Water and Wastewater Study Combined

PRELIMINARY Basis of Design Report	CITY OF					
		SCOTTSDALE					
	ACCEPTED AS NOTED						
	REVISE AND RESUBMIT	9379 E San Salvador Dr. Scottsdale, AZ 85258					
	Disclaimer: If accepted; the preliminary approval the condition that a final basis of design report w submitted for city review and approval (typically PP case). The final report shall incorporate furthe design and analysis requirements as defined in t standards and policy manual and address those the preliminary review comments (both separate herein). The final report shall be submitted and a the plan review submission. For questions or clarifications contact the Water Planning and Engineering Department at 480-31	ill also be during the DR or er water or sewer he city design items noted in and included approved prior to Resources					
	BY Idillon DATE	5/11/2020	2	Anna	Ninc	orino	<u>.</u>
	Address comments below and herein BOD. Conform to stipulations listed.	on a final	planr

SOUTHDALE

FINAL WASTEWATER BASIS OF DESIGN REPORT

Preliminary Onsite Utility Plans

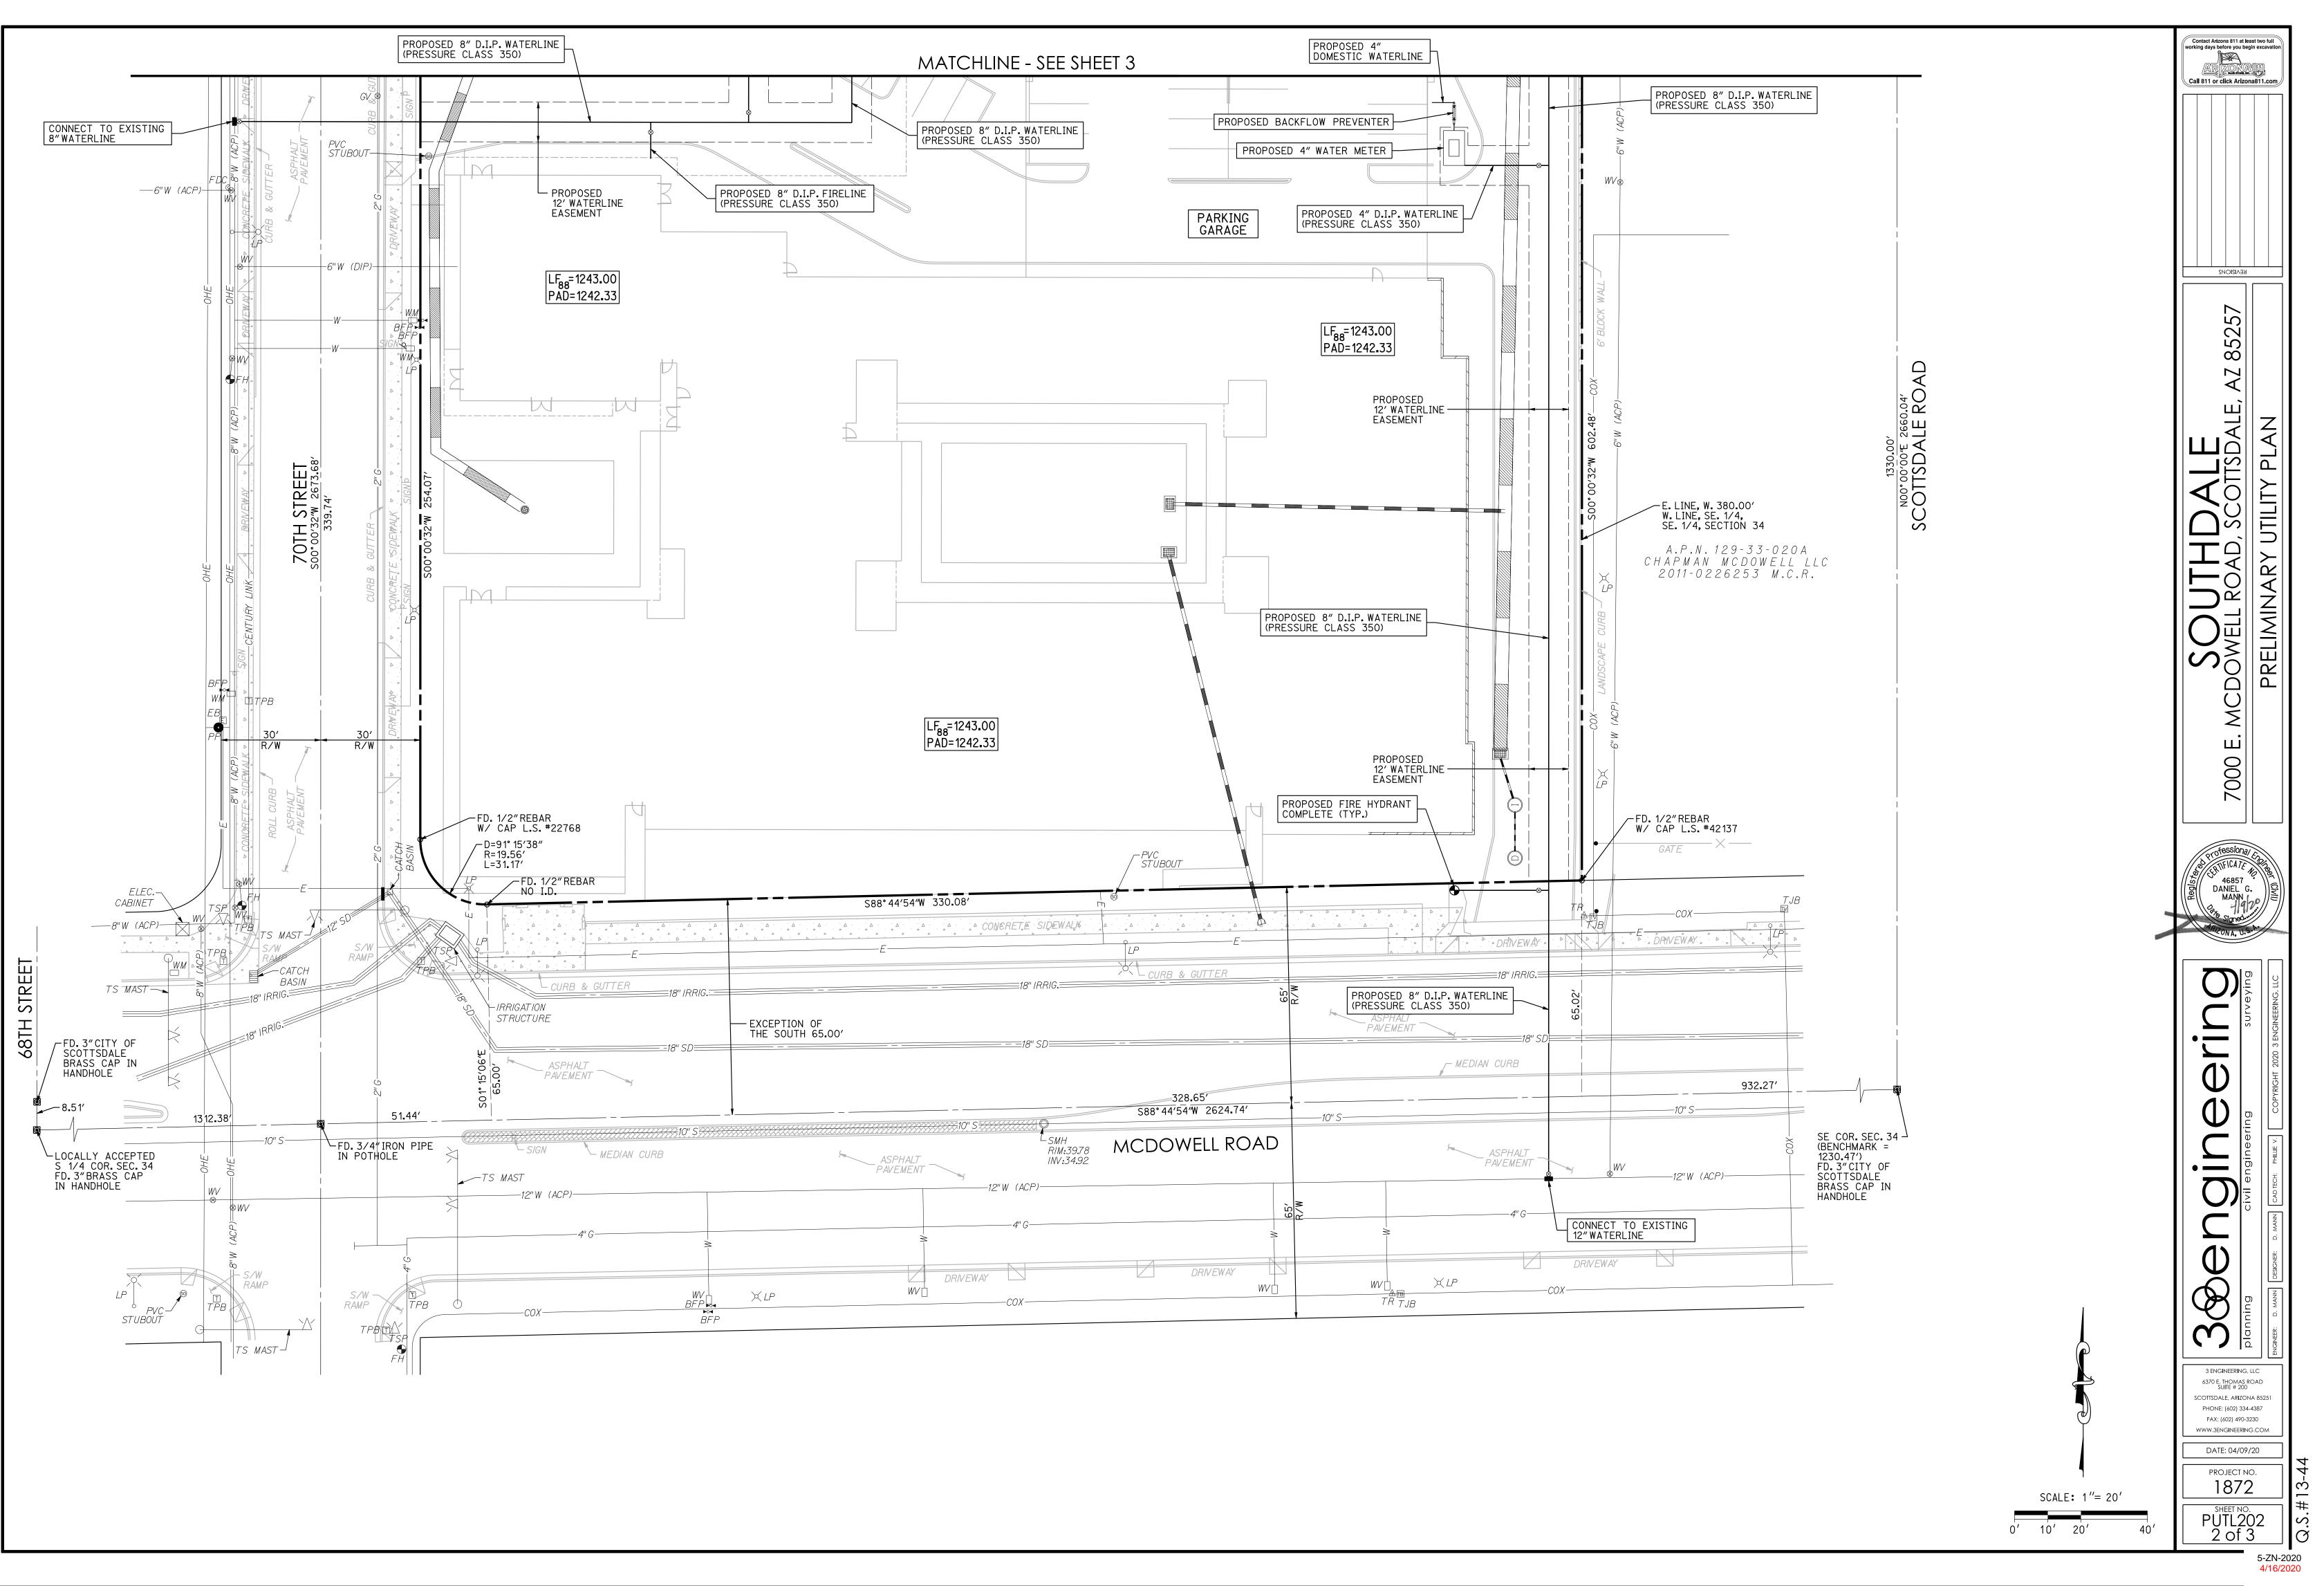
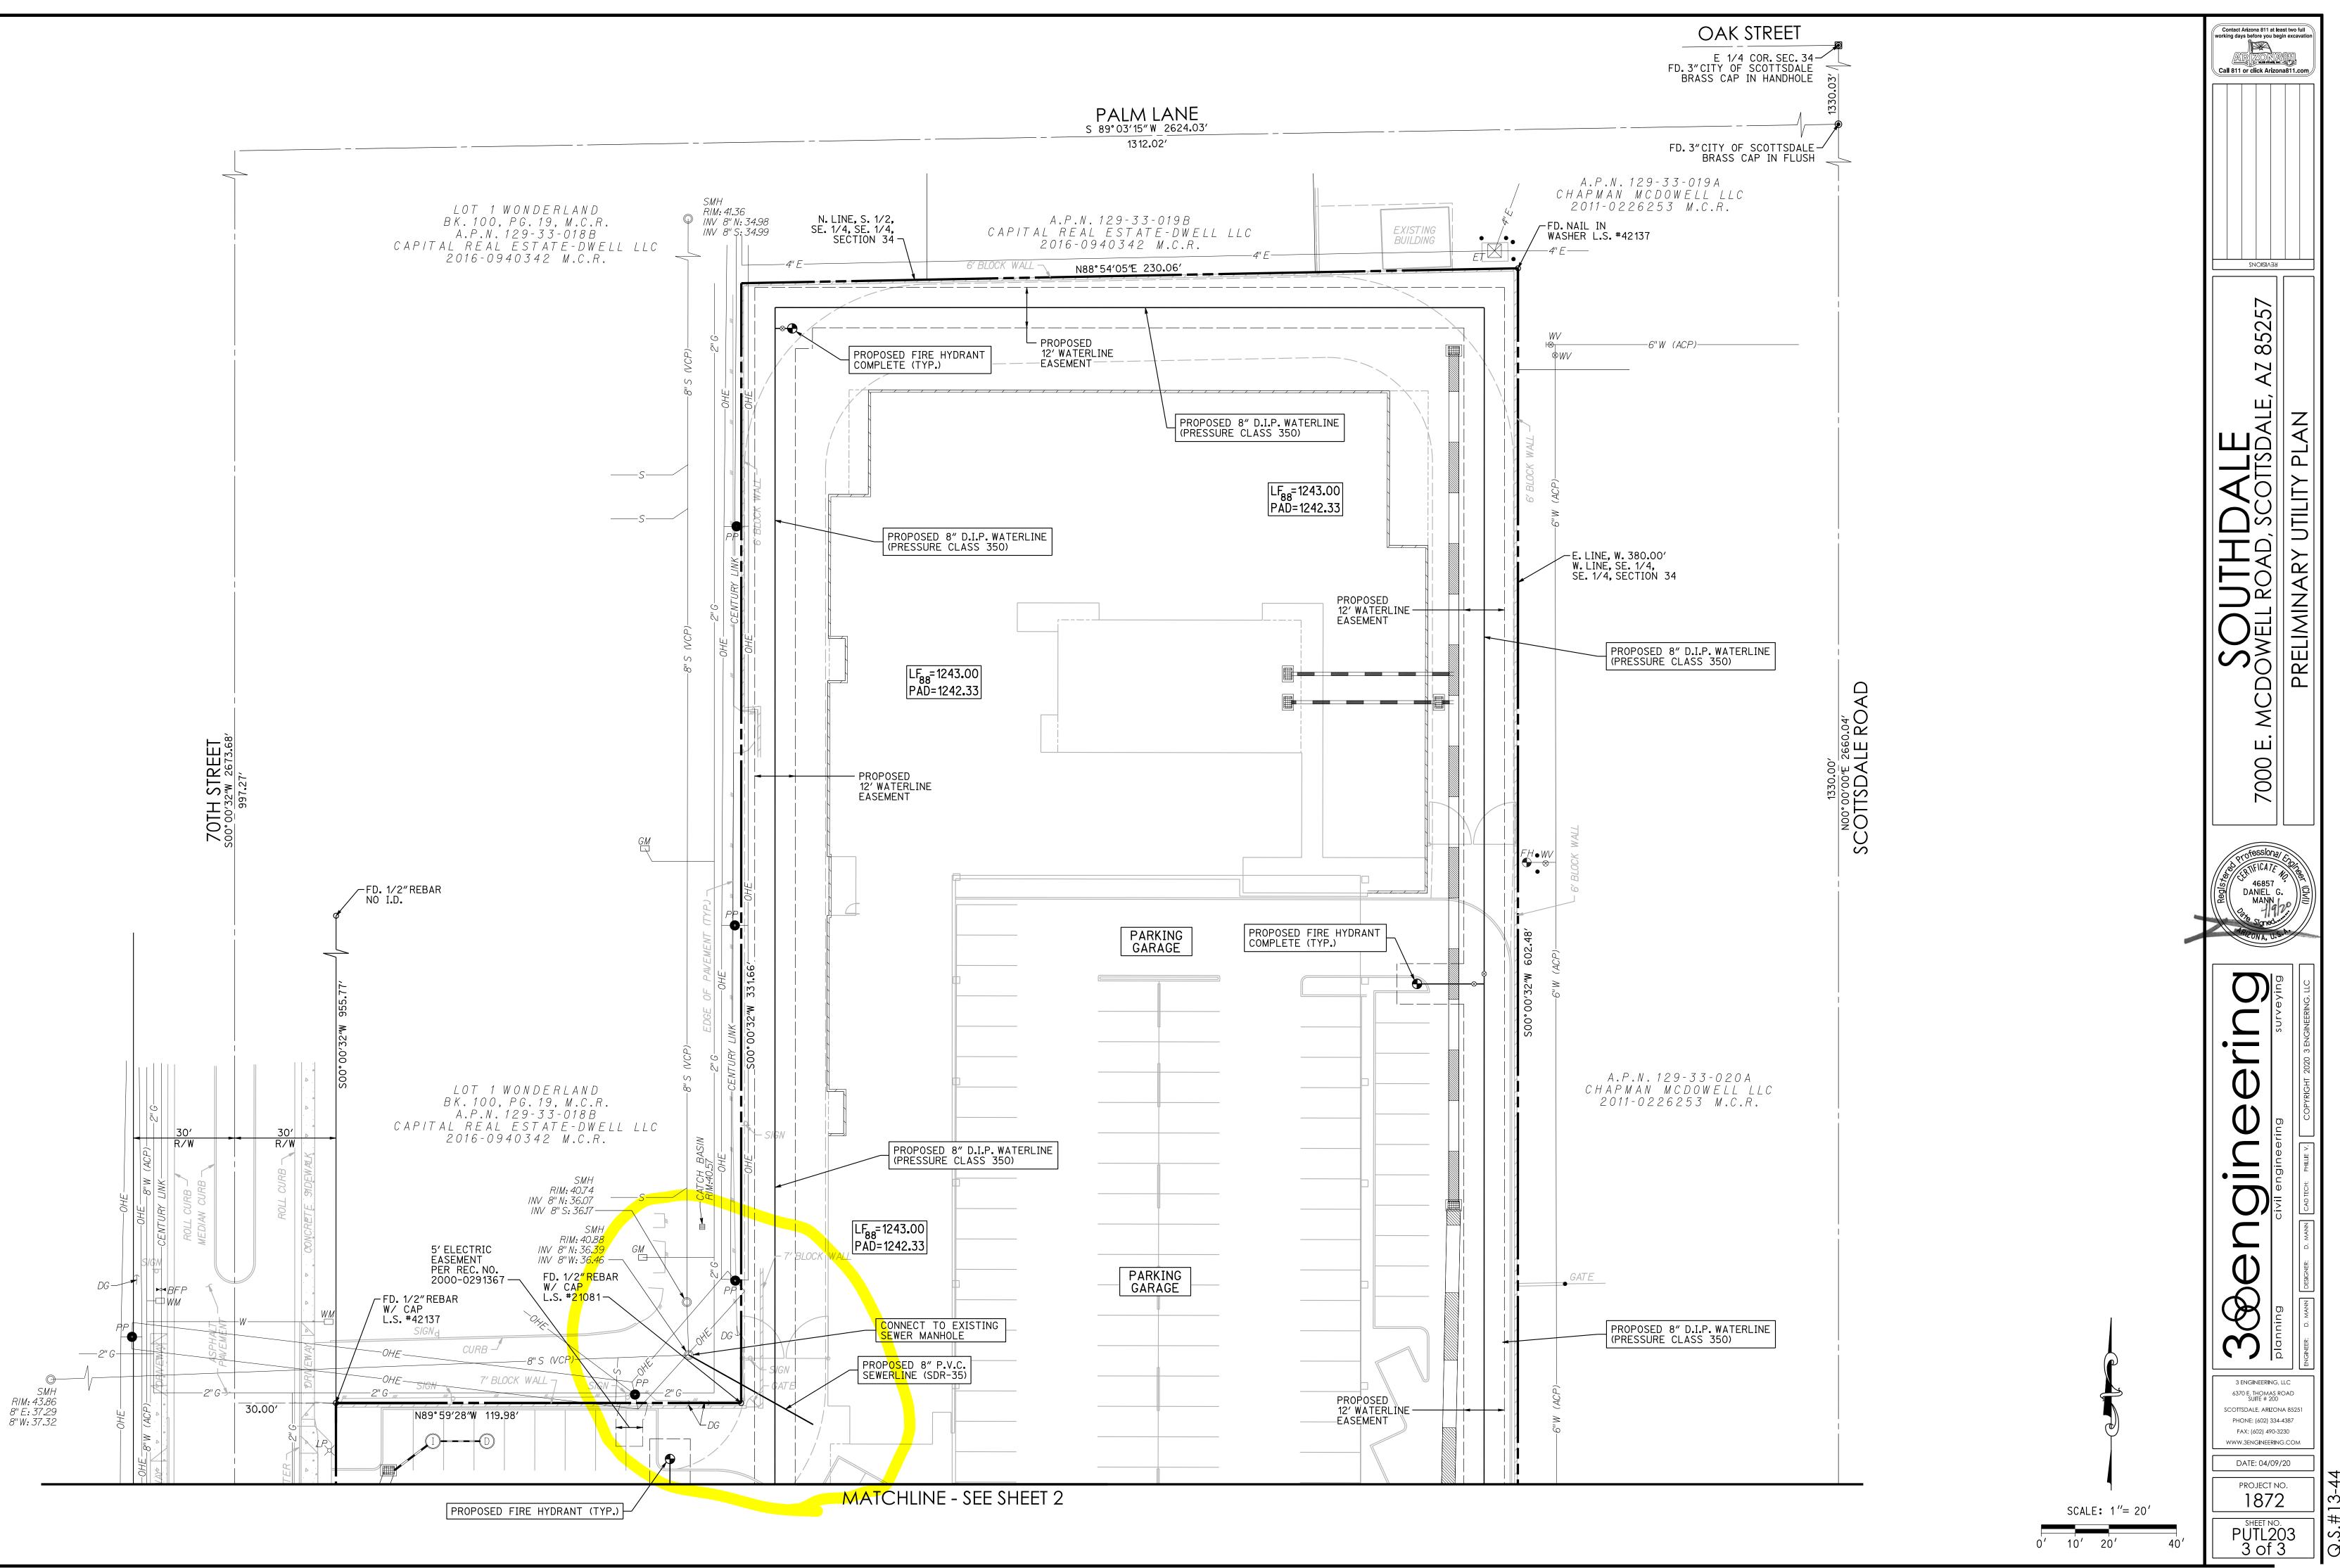
11.) Address all comments marked up on utility plan.
